YEAR 5 MONITORING REPORT

UT MILLERS CREEK

DMS Project ID No. 95719, Contract No. 5000, USACE Action ID No. SAW-2013-00386

Re: UT to Millers Creek Draft Year 5 Monitoring Report
Cape Fear River Basin, CU 03030006, Duplin County, DMS Project No. 95719

Current Condition Plan View - Year 5
 UT Millers Creek, Duplin County, North Carolina

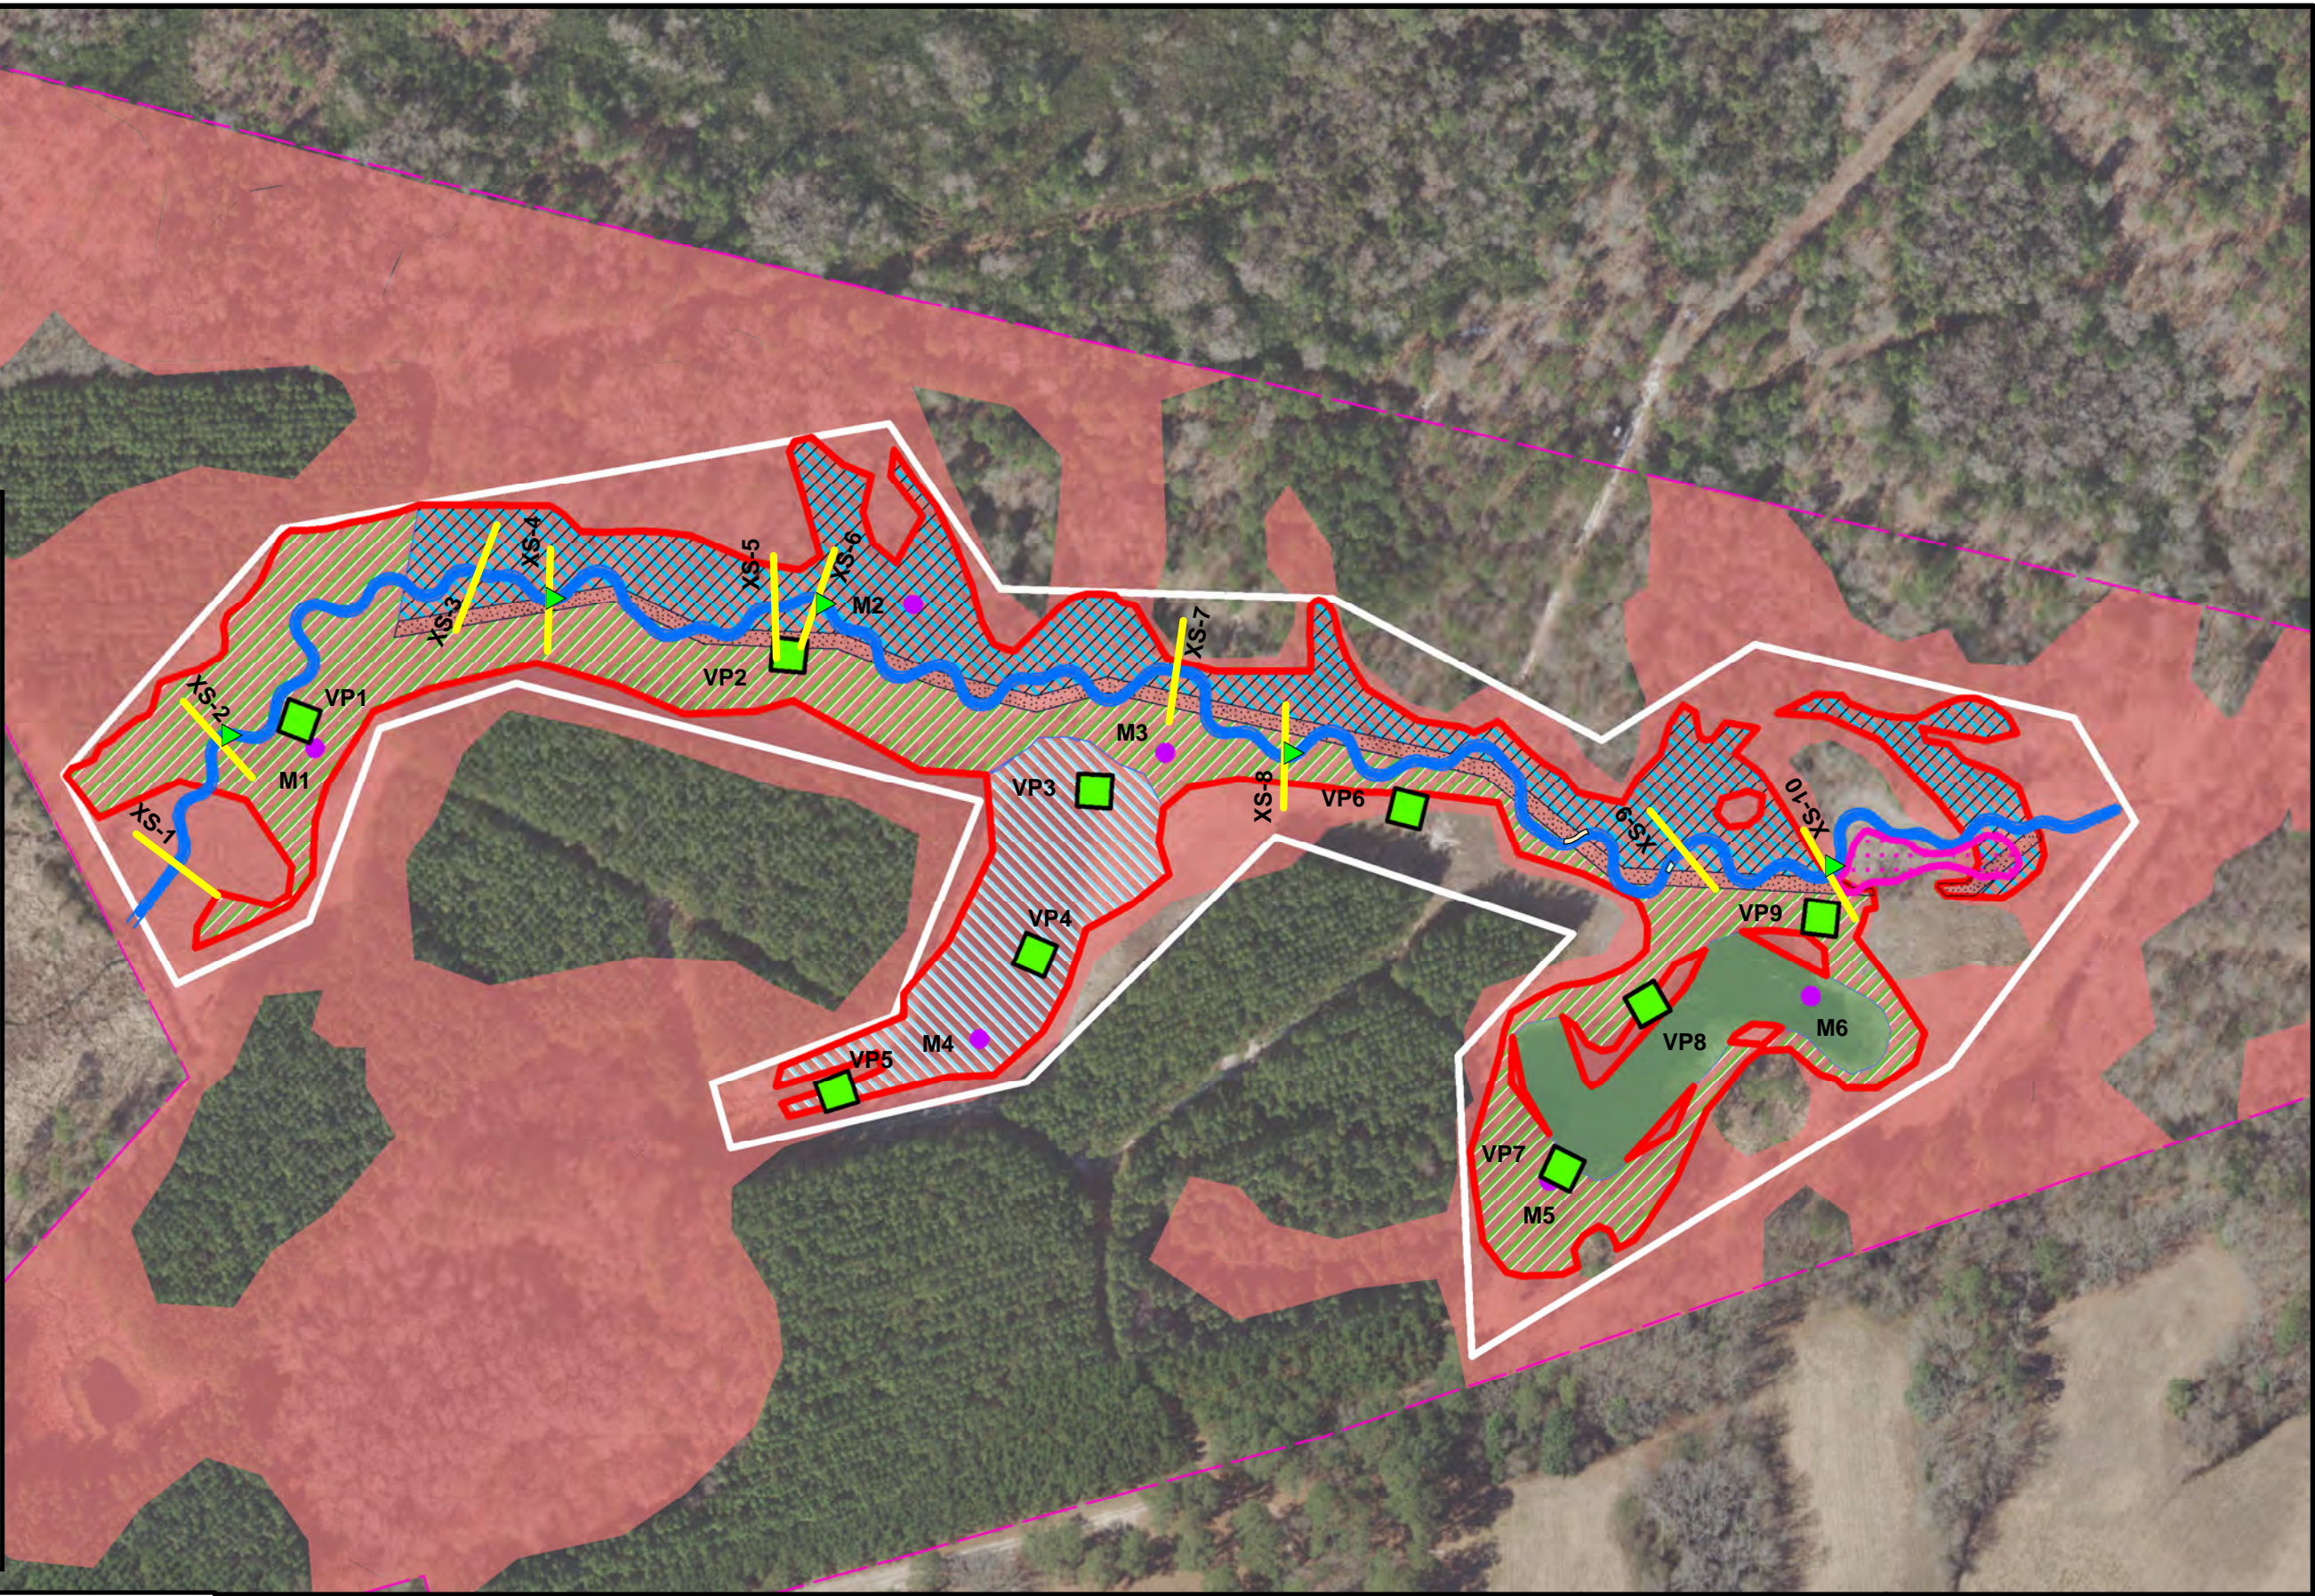
1. Appendix E, Table 11. Bankfull events. Please update this table to show cumulative bankfull events (merge this table with Appendix C of MY4 monitoring report table.)
2. CCPV. The Pond area is show as shaded but appears outlined on the CCPV.

Figure 4.1, XS-1 Riffle

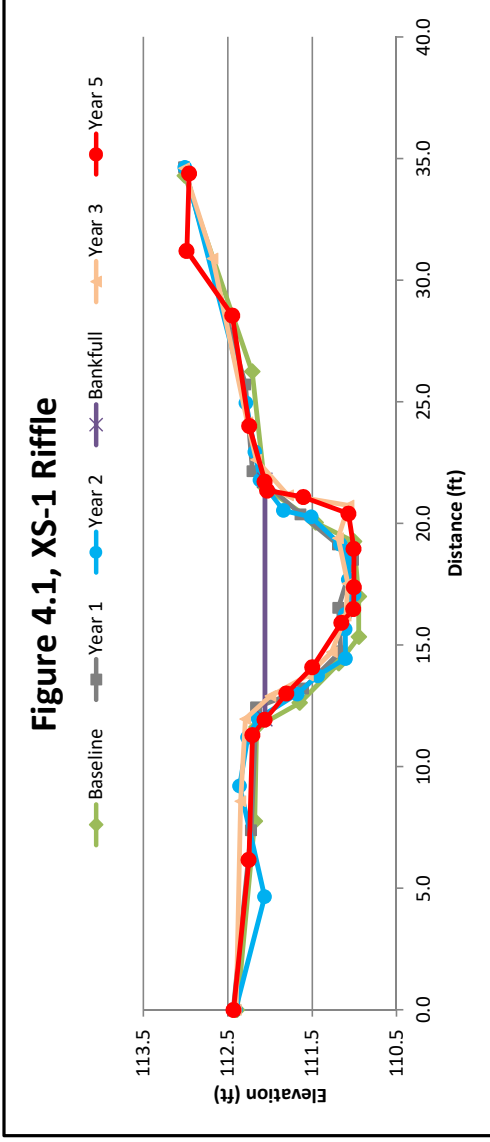
- In table 9, BHR for XS 1 is listed as > 1 but should be < 1
- At next gauge download, please provide DMS with the hydrology data files where the report leaves off (post October 19th, 2019).
